9.1 NO. 128A (LOT: 2; STR: 80812) HAROLD STREET, MOUNT LAWLEY - PROPOSED ALTERATIONS AND ADDITIONS TO GROUPED DWELLING

PURPOSE OF REPORT:

To consider an application for development approval for alterations and additions to an existing grouped dwelling at No. 128A Harold Street, Mount Lawley (the subject site).

Boundary Wall to North West

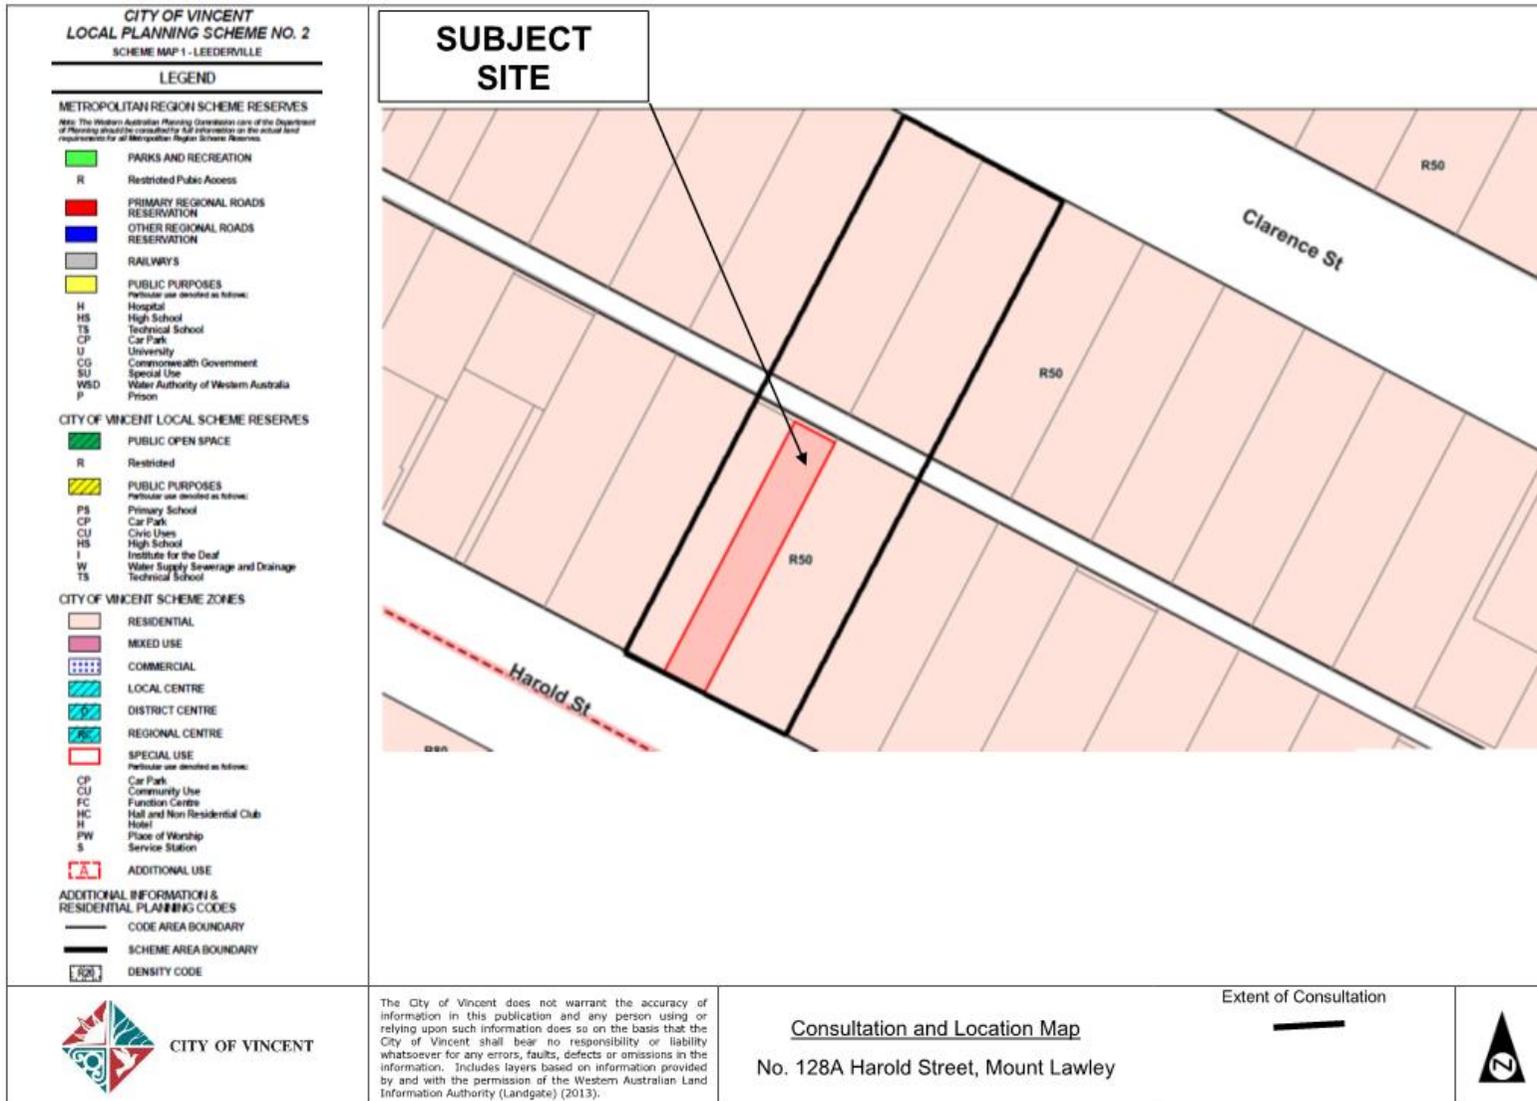
The R Codes deemed to comply standard permits boundary walls to two sides with a height of 3.5 metres and length of 22.2 metres, being two thirds the balance of the lot boundary behind the front setback.

The privacy screen proposed to the north west of the first floor terrace is 7.6 metres in length and 1.3 metres in height and would be on top of an existing parapet wall. The proposed privacy screen to the first floor terrace would extend the existing boundary wall along the north western lot boundary by 7.6 metres to a total boundary wall length of 31.3 metres. The proposed privacy screen would also result in a 1.3 metre increase to the existing boundary wall height for this portion of the boundary to a height of 6.1 metres.

- Mitigating Building Bulk:
 - The boundary wall extension would abut the garage of the adjoining property to the north-west. This would limit the impact associated with building bulk, as this area is void of any habitable rooms and living spaces; and

- The proposed increase of 1.3 metres in height of the existing boundary wall would be due to the installation of aluminium privacy screening. The screen would be of varying material and colour to the existing parapet wall that would assist with breaking up the mass, reducing the appearance of blank walls and creating visual interest.

- Visual Privacy:
 - The proposed privacy screening on top of the existing parapet wall would restrict views west from the terrace area and assists in making more effective use of the proposed outdoor living area. The screening would be 2.7 metres in height measured from the terrace floor level and meets the deemed-to-comply standard of the R Codes in relation to visual privacy; and

- Ventilation: The proposed boundary wall extension abuts the roof area of the adjoining property's garage to the north west. The boundary wall would not restrict ventilation to any windows or living areas of the subject site or adjoining property.

- Solar Access: The proposed boundary wall extension does not restrict direct sunlight to the north western adjoining property including its highlight window to bed 3 on the first floor. This is because the

shadow cast from the boundary wall and as measured in accordance with the R Codes would be cast to the south onto the proposed terrace area and subject site itself. The proposed boundary wall extension would not contribute to additional overshadowing of any of the adjoining properties.

Title
 FLOOR PLAN

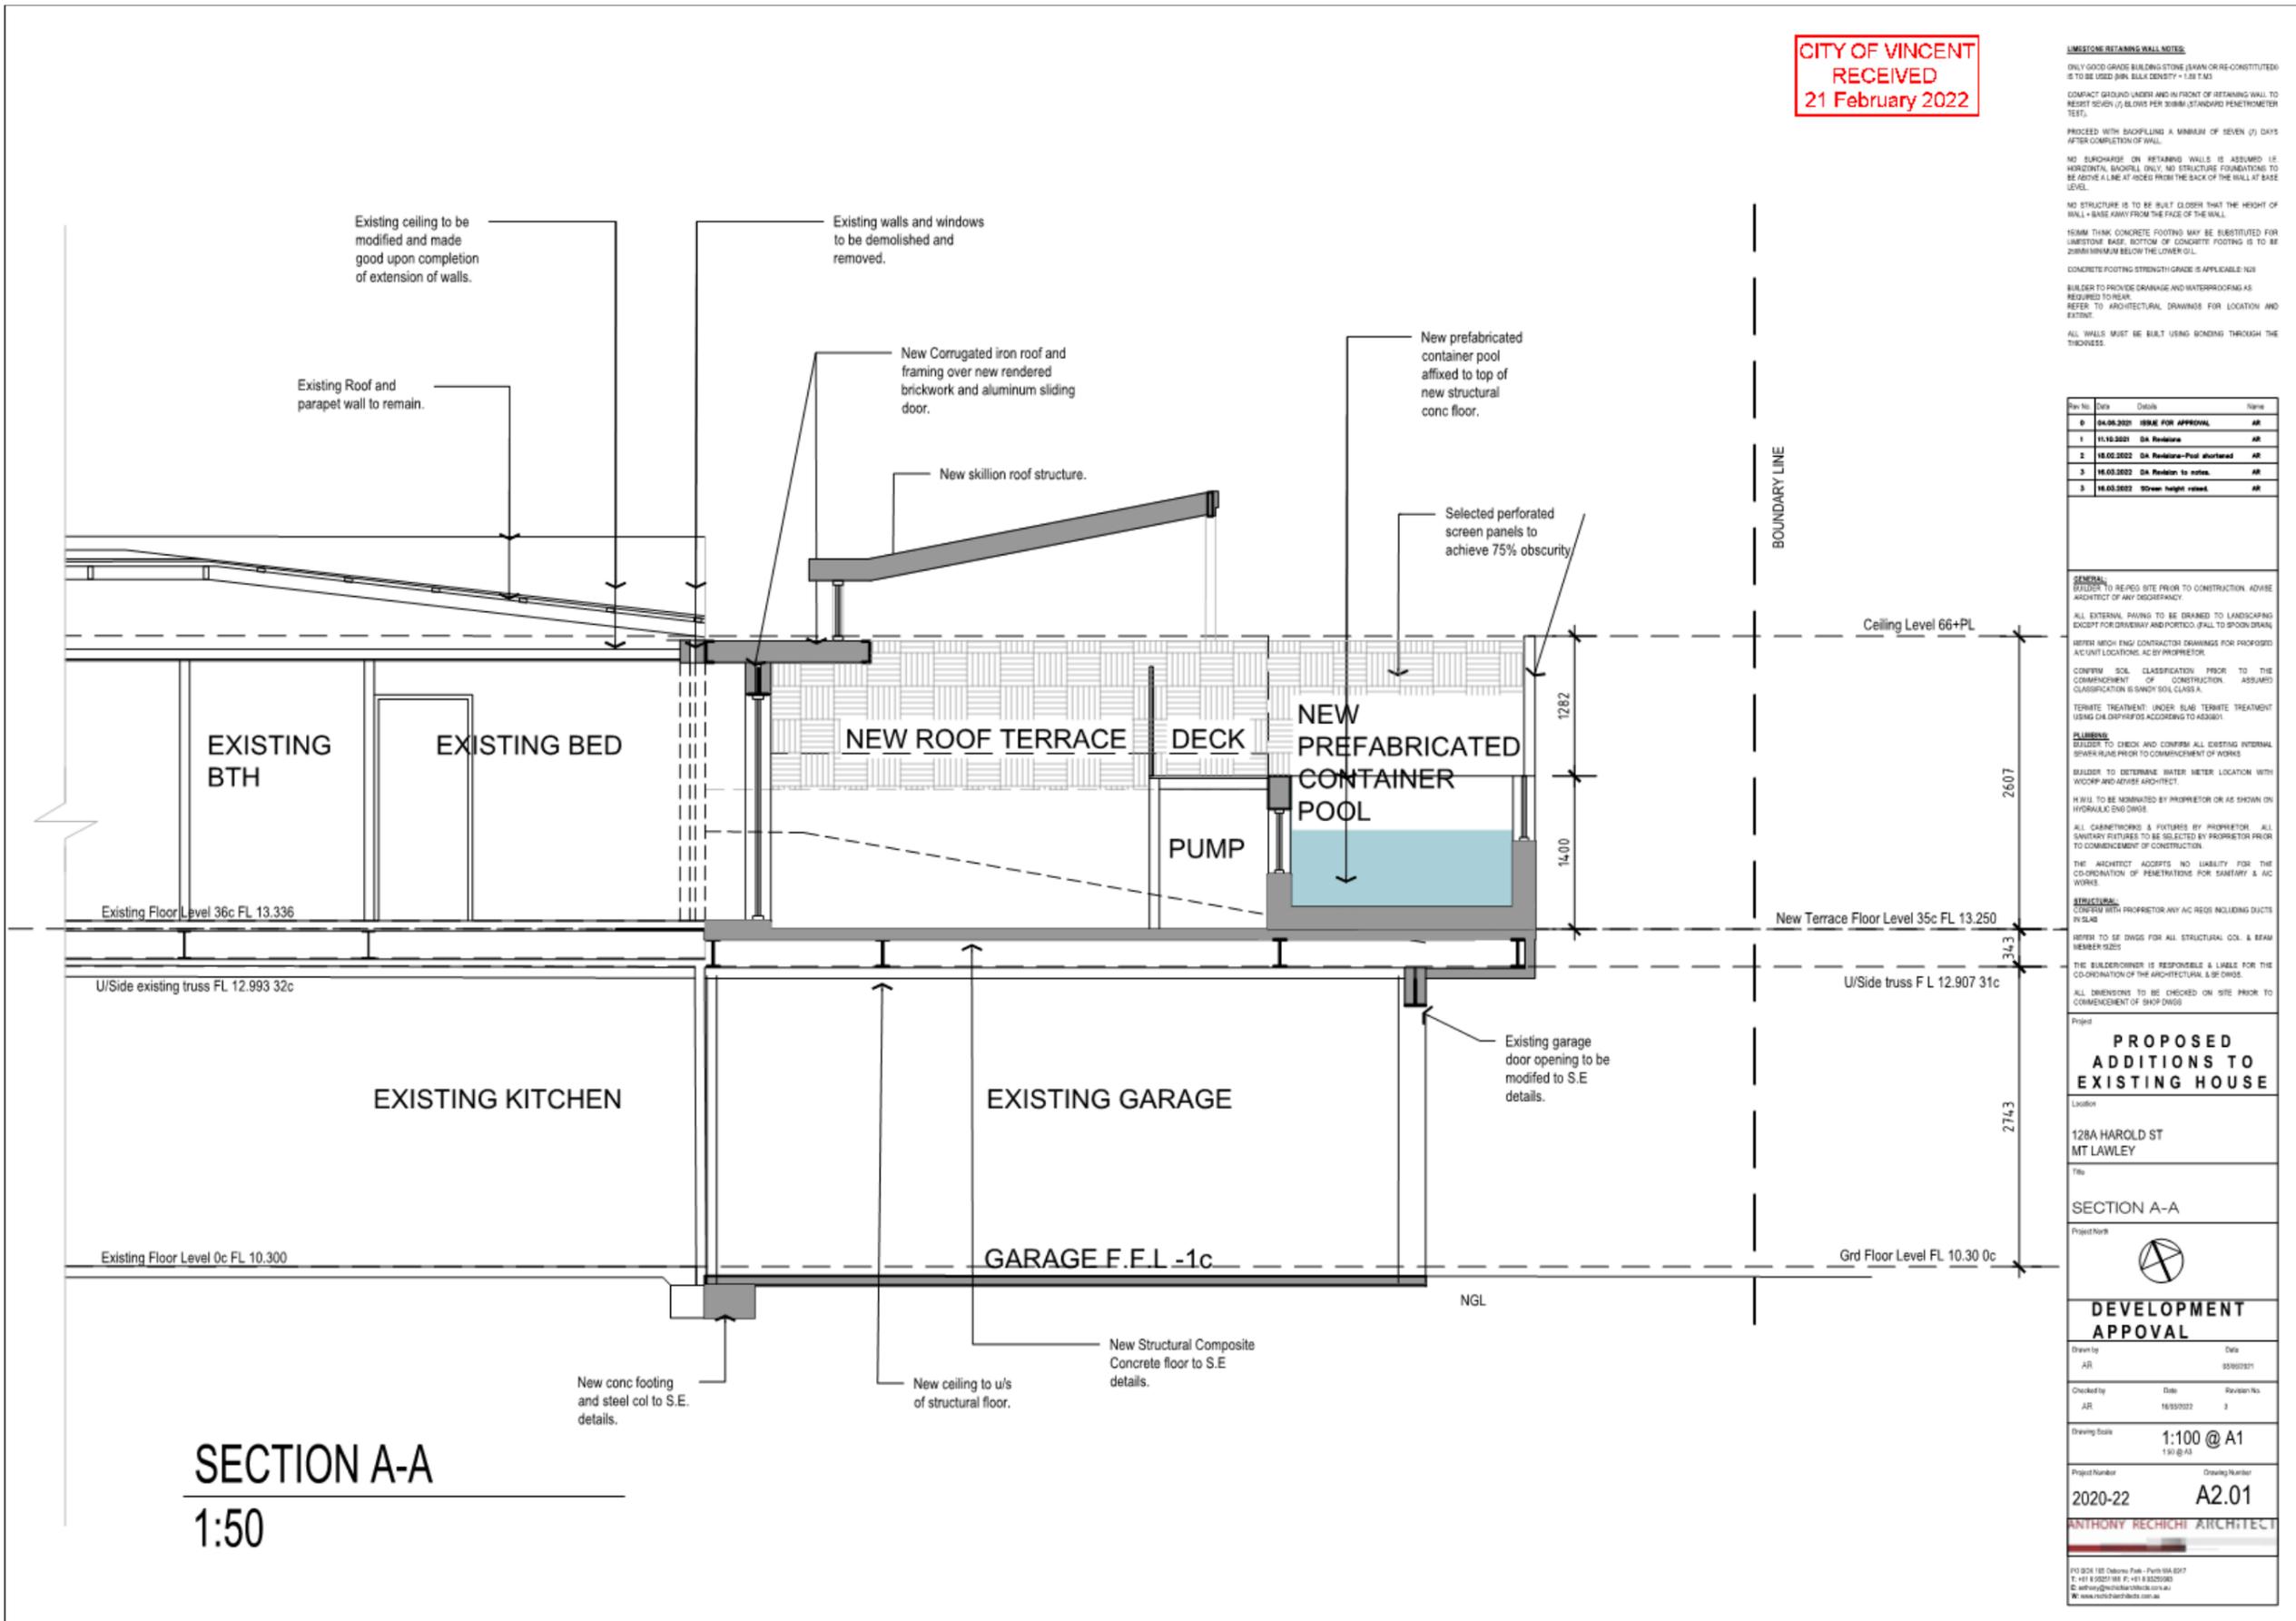
Lot Boundary Setbacks/Boundary Wall	
Deemed-to-Comply Standard	Proposal
R Codes – Clause 5.1.3	
<u>Boundary wall length</u> Maximum permitted length of 22.2 metres	First floor terrace north western boundary wall length of 31.3 metres
<u>Boundary wall height</u> Maximum permitted height of 3.5 metres	First floor terrace north western boundary wall height of 6.1 metres (inclusive of screen panels)
<u>Lot boundary setback</u> 2.6 metre setback for a building with a maximum height of 7.1 metres to the top of skillion roof over the terrace, and a total length of 19.5 metres inclusive of the existing dwelling wall	First floor terrace south eastern boundary setback of 1.1 metres

- Increased setback of privacy screen on first floor terrace to south eastern boundary from 0.645 metres to 1.1 metres; and
- Removal of the proposed retractable staircase located to the east of the existing bedroom on the first floor.

- The increased setback to the roof terrace is an improvement and reduces the impact to the adjoining properties and ROW. It is noted that it does not meet R Codes deemed to comply provisions, but it is consistent with the setback to the upper storey wall along this side. The transition to a lightweight privacy screen at 1.6 metre height further mitigates bulk/scale impacts.

- The increased setback to the eastern lot boundary should provide a reduction in the shadow cast over the eastern property and the privacy screen having a height of 1.6 metres to this location.

COMMENTS:Lot Boundary Setback to South East

The R Codes deemed to comply standard sets out the wall on the first floor to be setback 2.6 metres from the south eastern lot boundary.

A privacy screen is being proposed to the south east of the first floor terrace that would be on top of an existing wall. This privacy screen would measure 7.6 metres in length and 1.6 metres in height. This privacy screen addition would result in a continuation of the existing dwelling first floor wall along the south eastern boundary by 7.6 metres, to a total height of 5.1 metres and setback 1.1 metres to this side boundary. The roof over the terrace would be 7.1 metres in height. The remainder of the existing dwelling first floor wall to this south eastern boundary is 11.9 metres in length, 6.6 metres in height and setback 1.1 metres.

- Mitigating Building Bulk:
 - The top of the privacy screen would be 5.1 metres in height measured from natural ground level which is 1.5 metres less than the existing south eastern first floor wall of the dwelling that it would adjoin. The stepping down of height would assist in reducing the impact of the building bulk associated with the first floor wall to the south eastern adjoining property;

- Visual Privacy:
 - The proposed privacy screening is 1.6 metres in height measured from the terrace floor level. This would restrict views from the terrace area to the adjoining properties and complies strictly with the deemed-to-comply standards of the R Codes in relation to visual privacy. A condition of approval has been recommended requiring privacy screening to be installed prior to use of the terrace area; and

- Ventilation: The proposed setback of 1.1 metres between the proposed privacy screen and the south eastern lot boundary provides separation to allow for sufficient ventilation to the subject site and adjoining property.

- Increased setback of privacy screen on first floor terrace to south eastern boundary from 0.645 metres to 1.1 metres;
- Removal of planting area along the 1.1 metre setback on top of the garage roof to the eastern boundary; and
- Removal of the proposed retractable staircase located to the east of the existing bedroom on the first floor.

EAST ELEVATION
1:50

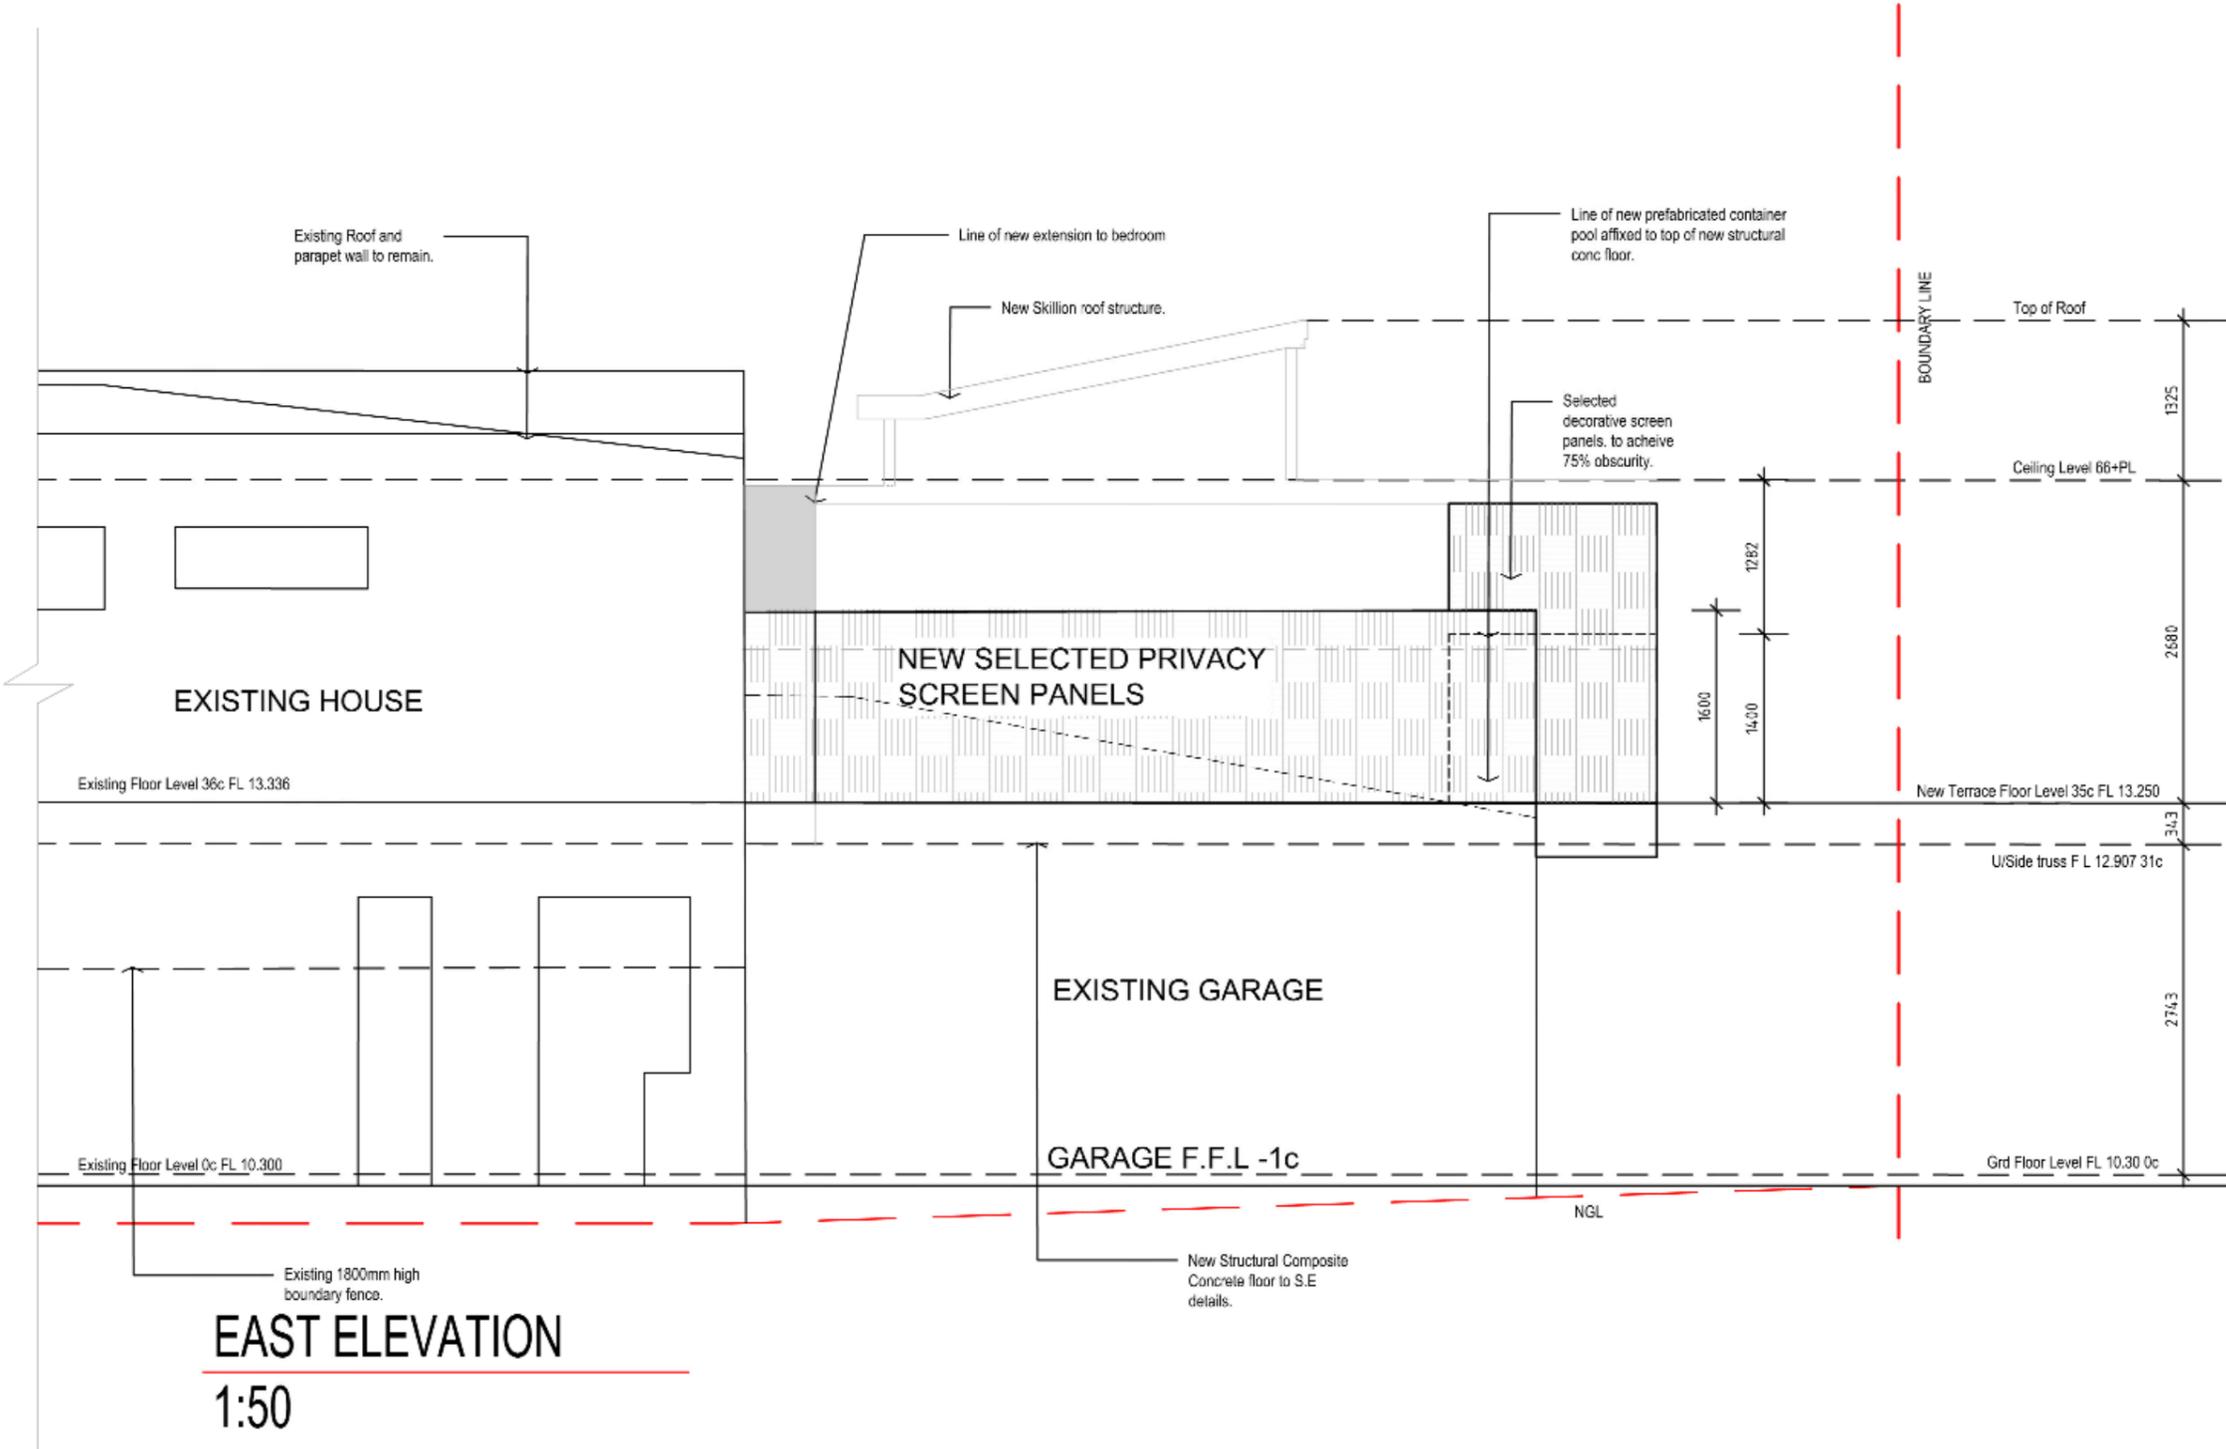
- The proposed aluminium privacy screening on the first floor would provide a contrast in colours and materials from the existing ground and first floors when viewed from the adjoining property. The privacy screens would be a neutral colour tone. The existing dwelling is constructed from white rendered brick wall and face brick boundary walls. This contrast would successfully delineate and distinguish the first floor from the ground floor to assist in reducing the extensions bulk impact. The view from the eastern adjoining property to the area where the terrace is proposed is currently the roof of a garage, air conditioner and parapet blade wall beyond;
